Periodic Dam Safety Inspection Report

Beitey Lake Dam
Stevens County, Washington

June 2001
Pub. No. 01-11-009

Beitey Lake Dam - Crest Profile Looking Upstream
Figure 6 - Repair Option 1: Construct 10 Foot Wide Emergency Spillway

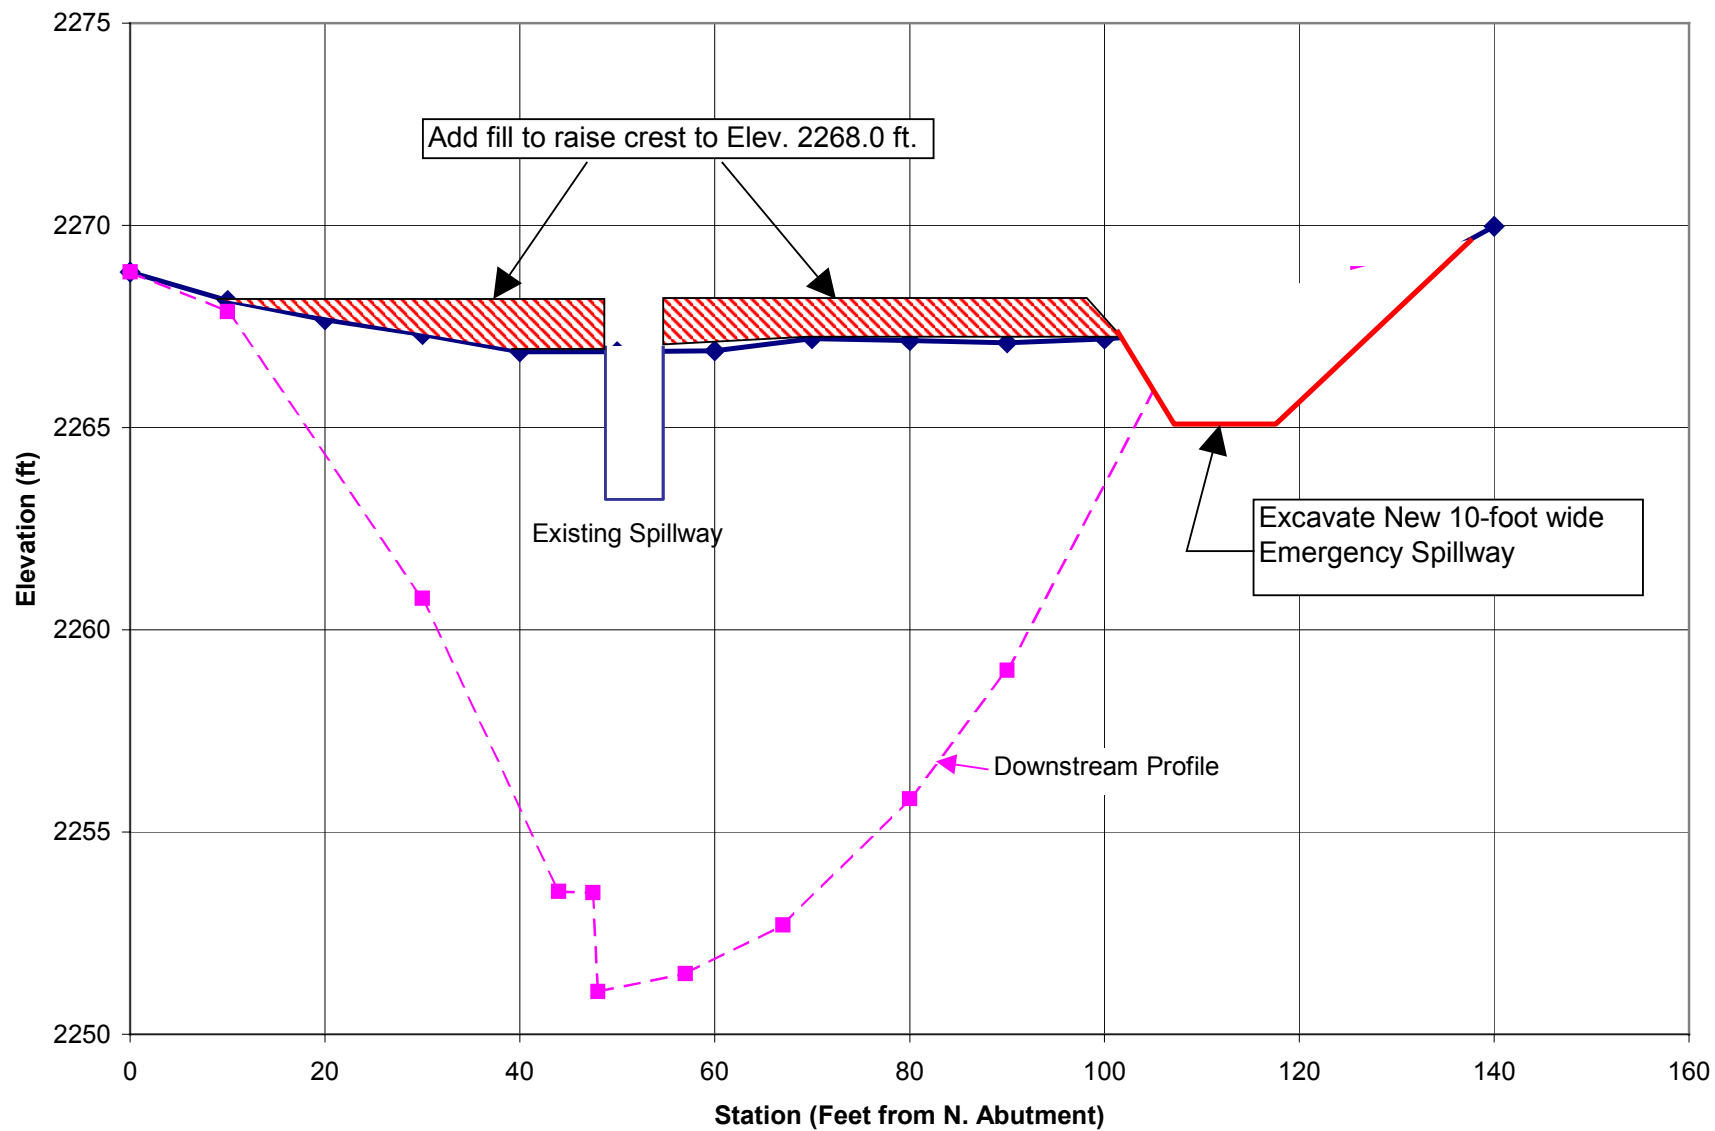
Option 1: 10 foot wide emergency spillway – This option would involve excavating a 10-foot wide emergency spillway around the left (south) abutment of the dam with a floor elevation of 2265 feet, and adding one foot of fill to the dam crest to raise the elevation to 2268.0 feet. Figure 6 provides a conceptual drawing of this repair scheme. With these modifications, the dam can handle the IDF with 0.6 feet of freeboard below the crest elevation. The advantage of this scheme is that it would be relatively easy and inexpensive to construct. The disadvantage is that it would require extensive regrading of the road on the left abutment to maintain access across the dam for logging trucks. Also, the concrete sidewalls of the spillway chute would have to be raised one foot.

1. **Construct 10 foot wide emergency spillway** – This option would involve excavating a 10-foot wide emergency spillway around the left (south) abutment of the dam, and adding one foot of fill to the dam crest to raise the elevation to 2268.0 feet. Figure 6 provides a conceptual drawing of this repair scheme.

Beitey Lake Dam - Crest Profile Looking Upstream
Figure 7 - Repair Option 2: Install Twin 36-inch Pipes

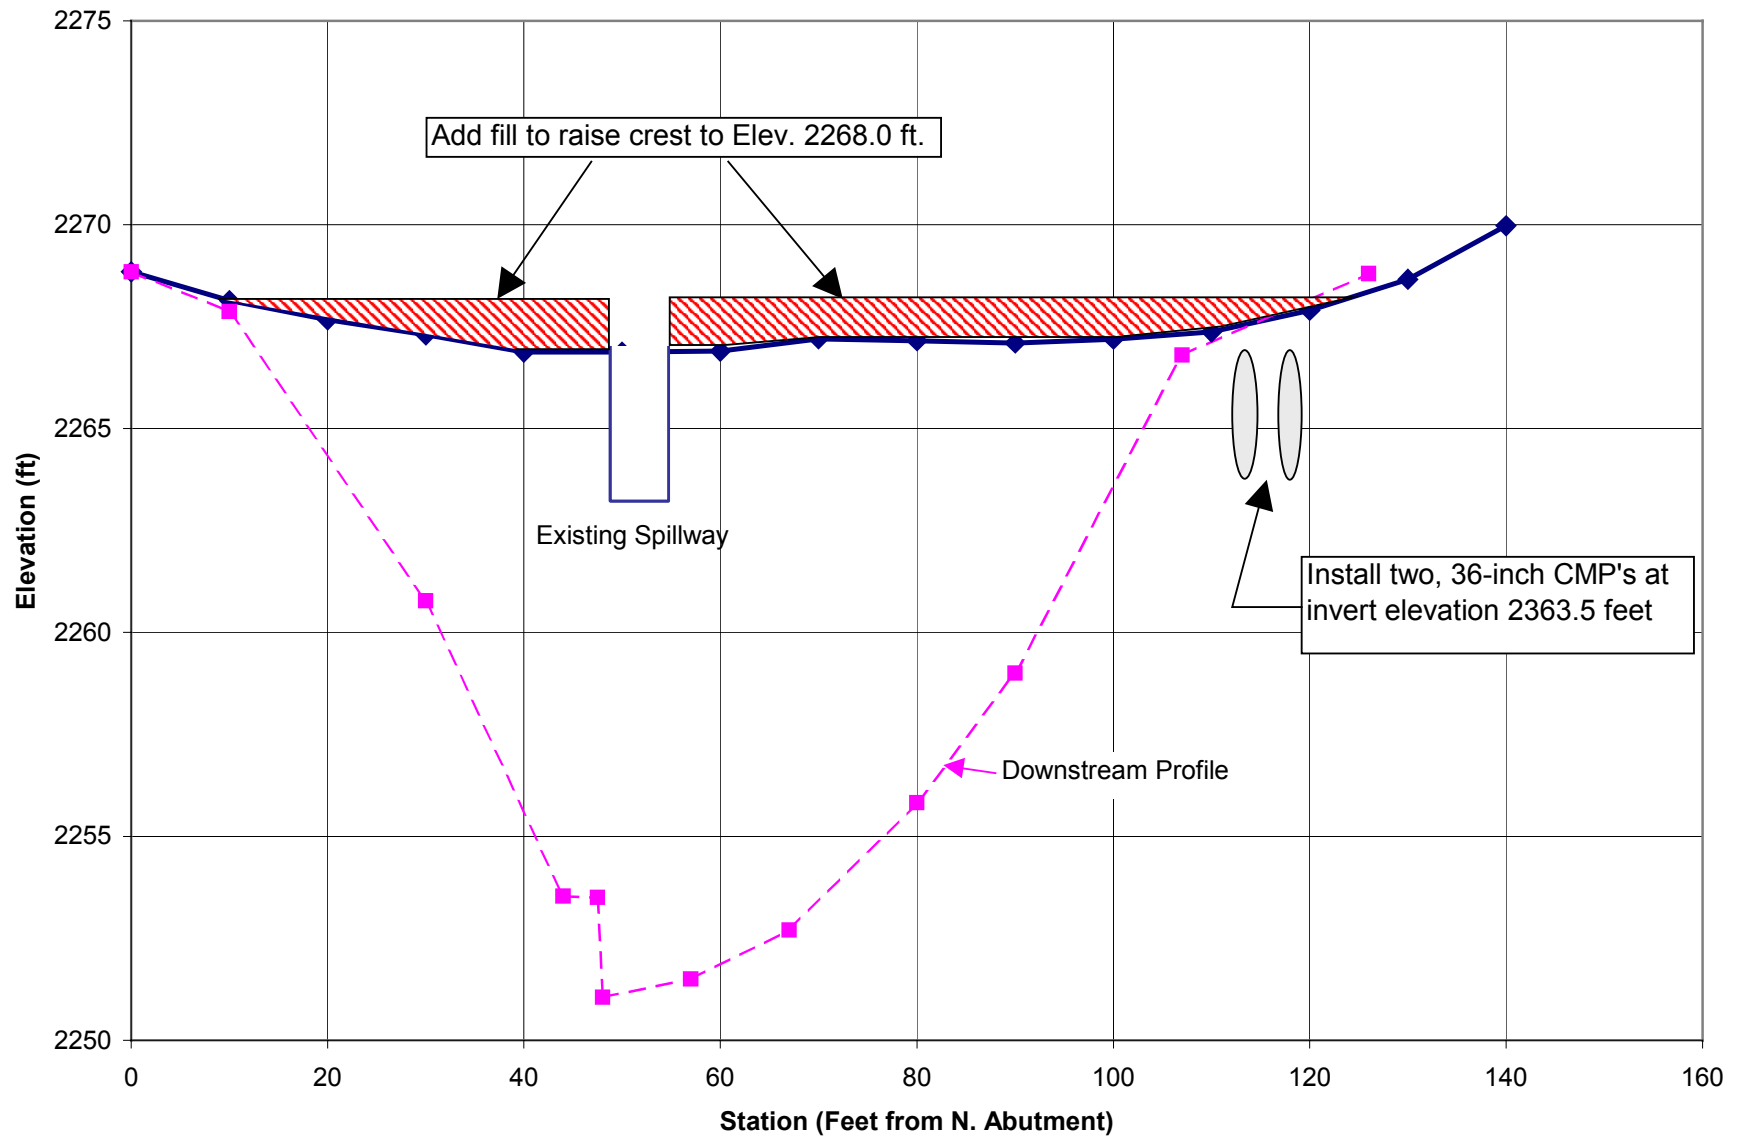
Option 2: Install Two 36-inch Pipes on Left Abutment – This option would involve installing twin 36-inch diameter Corrugated Metal Pipes through the left abutment of the dam, with the invert elevation of the pipes at 2263.5 feet (Figure 7). The pipes would discharge into a channel on the downstream left abutment that would direct spillway flows away from the toe of the dam. Under this repair scheme, the dam could pass the flood with 0.5 feet of freeboard below the crest. The advantage of this scheme is that the dam crest and existing spillway walls would not have to be raised, and the road over the dam would not require regrading. The disadvantage would be the cost of purchasing and installing the conduits.

2. **Install Two 36-inch Pipes on Left Abutment** – This option would involve installing twin 36-inch diameter Corrugated Metal Pipes through the left abutment of the dam, with the invert elevation of the pipes at 2263.5 feet. The pipes would discharge into a channel on the downstream abutment that would direct spillway flows away from the toe of the dam. Figure 7 provides a conceptual drawing of this repair scheme.

Beitey Lake Dam - Crest Profile Looking Upstream
Figure 8 - Repair Option 3: Overtopping Protection for Crest

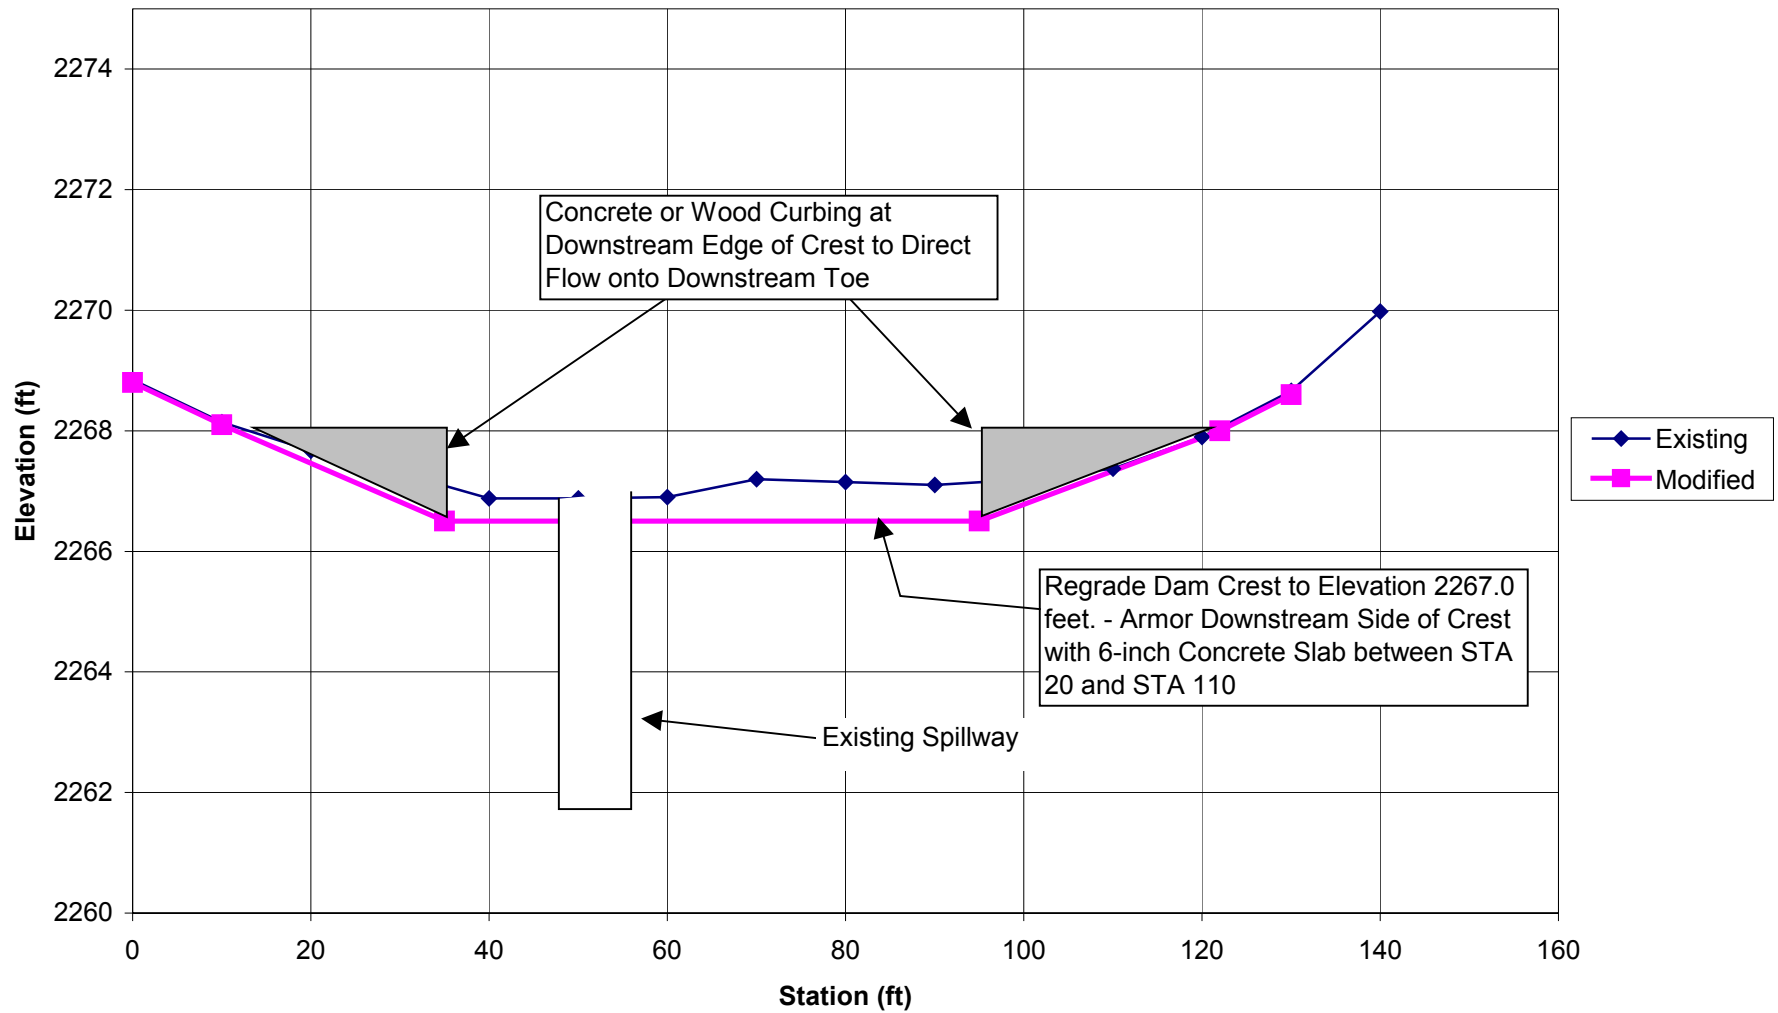
Option 3: Make Dam Overtoppable – This option would involve providing a concrete surfacing on the dam crest to enable it to withstand overtopping flows (Figure 8). First, up to 12 inches of fill would be removed from the dam crest to lower the crest elevation to 2266.0 feet. Next, a trench would be excavated to expose the top of the concrete core wall. This would allow dowels to be drilled into the top of the core wall to tie the overtopping protection to the core. Then a 6-inch thick concrete slab would be constructed across the dam crest and onto the core wall. Reinforcing steel would be required sufficient to support the weight of truck traffic. Formwork would be needed to extend the slab several inches beyond the downstream rock facing. Finally, curbing (either wood or concrete) would be needed along the downstream edge of the slab to direct the flows over the center of the dam. Figure 8 provides a conceptual drawing of this repair scheme. The advantage of this scheme is that all work would take place on the dam crest, and no work would be required in the abutment area. The disadvantage would be the higher complexity and cost of construction.

3. **Make Dam Overtoppable** – This option would involve providing a concrete surfacing on the dam crest to enable it to withstand overtopping flows. First, up to 12 inches of fill would be removed from the dam crest to lower the crest elevation to 2266.0 feet. Next, a trench would be excavated to expose the top of the concrete core wall. This would allow dowels to be drilled into the top of the core wall to tie the overtopping protection to the core. Then a 6-inch thick concrete slab would be constructed across the dam crest and onto the core wall. Reinforcing steel would be required sufficient to support the weight of truck traffic. Formwork would be needed to extend the slab several inches beyond the downstream rock facing. Finally, curbing (either wood or concrete) would be needed along the downstream edge of the slab to direct the flows over the center of the dam. Figure 8 provides a conceptual drawing of this repair scheme.

Figure 9 - Stilling Basin Conceptual Plan

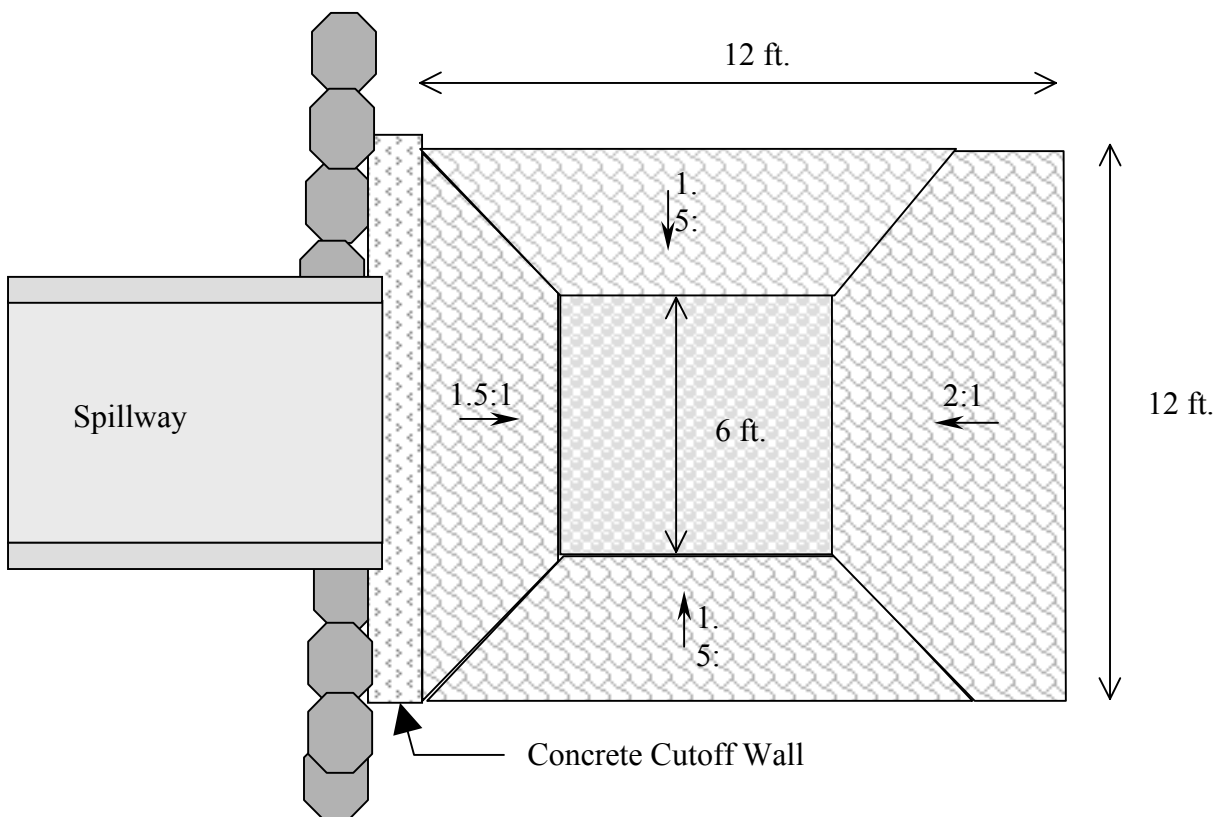
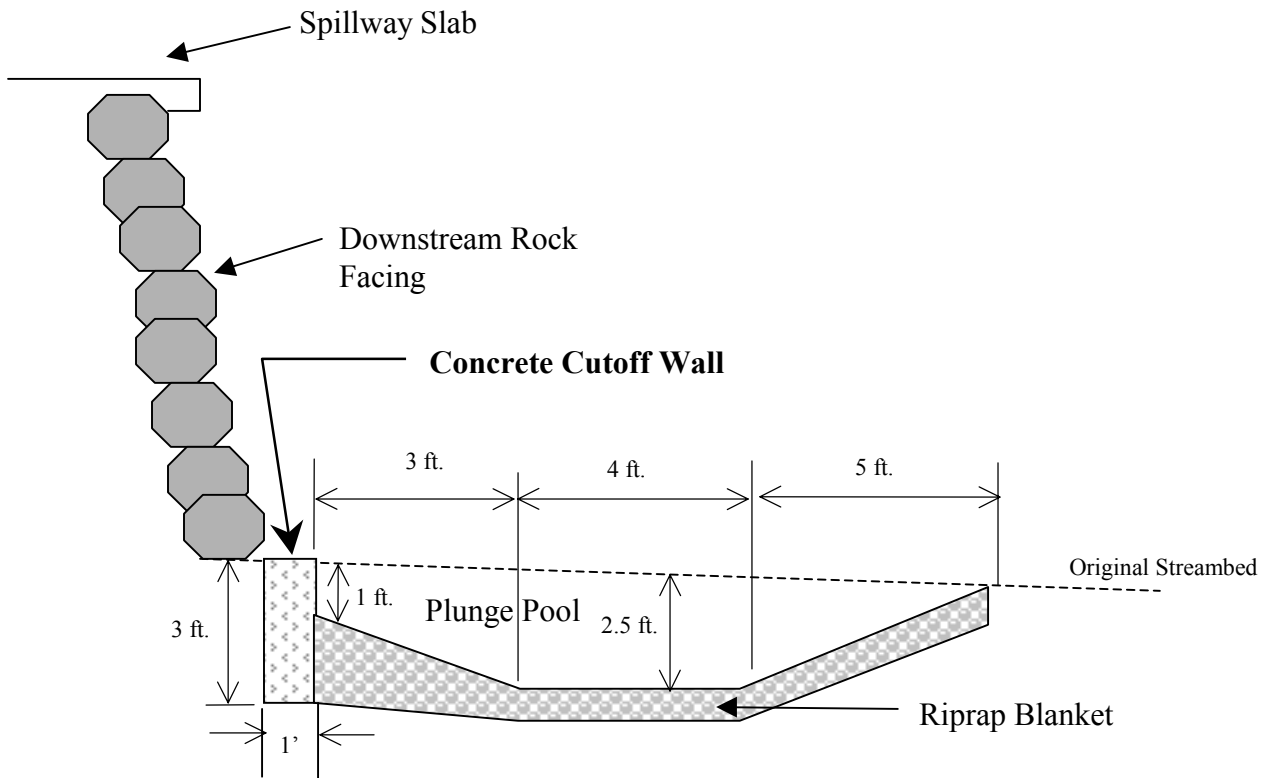
Currently, a prefabricated corrugated metal watering trough provides energy dissipation of spillway flows dropping from the chute to the downstream toe. This arrangement works fairly well for low flows, but would be overwhelmed by major flood flows, leading to erosion of the toe and undermining of the rock facing. A more substantial energy dissipator is needed to adequately handle flood discharge from the spillway. A simple solution to this problem would be to create a stilling pool in the stream channel at the downstream toe. This could be accomplished by excavating a basin 3 feet to 4 feet deep at the location of the metal trough. The basin should be about 7 feet wide and extend at least 10 feet downstream from the current location of the trough. The basin would be lined with riprap for erosion protection, and a concrete cutoff wall should be placed at the upstream end to prevent undermining of the downstream toe. Figure 9 shows a conceptual design for this stilling pool.
